Subject: Oconee Nuclear Station
Docket Numbers 50-269, 270, and 287
Response to Request for Additional Information
Pertaining to the License Amendment Request (LAR)
for RPS/ESPS Digital Upgrade
Technical Specification Change (TSC) Number
2004-09, Supplement 2

**Attachment 1 – Non Proprietary
Duke Response to Request for Additional Information (RAI)
Oconee Nuclear Station License Amendment Request
for RPS/ESPS Digital Upgrade**

Figure G2—Communication between safety channels (Two-way communication)

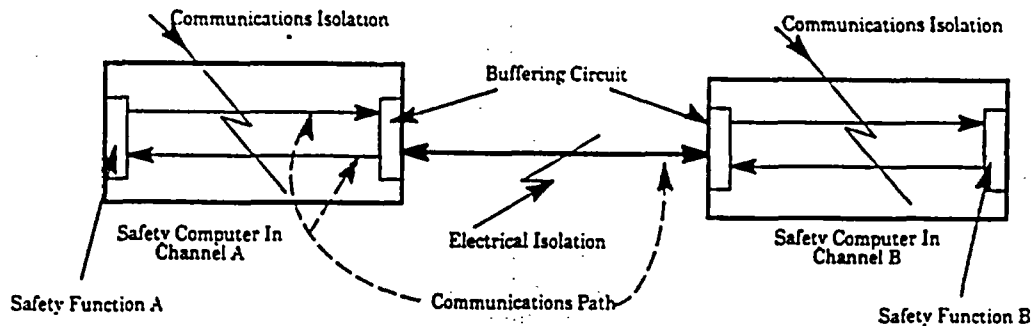
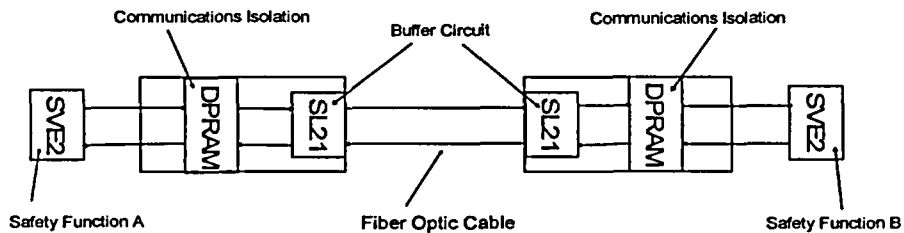
Please describe in detail all communications and data exchange between channels.

Through the use of buffering circuits, an acceptable method of inter-channel communication prevents adverse interactions such as hand-shaking errors, buffer overloads and processing interrupts. IEEE 7-4.3.2 Annex G provides Figure G2 as an acceptable method for meeting the separation requirements between safety channels. That figure is duplicated below:

The RPS/ESPS uses a similar inter-channel communication method. The figure below depicts the inter-channel communication method used within the RPS/ESPS:

The following table compares the components of the RPS/ESPS to Figure G2 of IEEE 7-4.3.2:

The RPS/ESPS communication path between two safety processors use SL21 communication interface modules and fiber optic cables to interface between separate safety channel processors. Through the use of dual port RAM (DPRAM), the SL21 interface, the processors can communicate autonomously, so that the safety function processing is not compromised. In addition, the SL21 removes the communication burden from the safety processors.

The DPRAM provides communications isolation by allowing the safety function processor and communications processor to operate completely independently. Data written to the DPRAM by the safety function processor can be read and transmitted at any time by the SL21 communications module. Similarly, data received by the communications module and written to the DPRAM can be read by the safety function processor at any time. Either processor can read and write from/to the DPRAM without any synchronization, control permissives or other interaction between the processors. This ensures that trip functions within the function processor can operate with no regard to operations of the redundant processors (e.g. no communication handshaking or latencies between channels). This results in cyclical, deterministic and asynchronous performance of all trip functions in all channels.
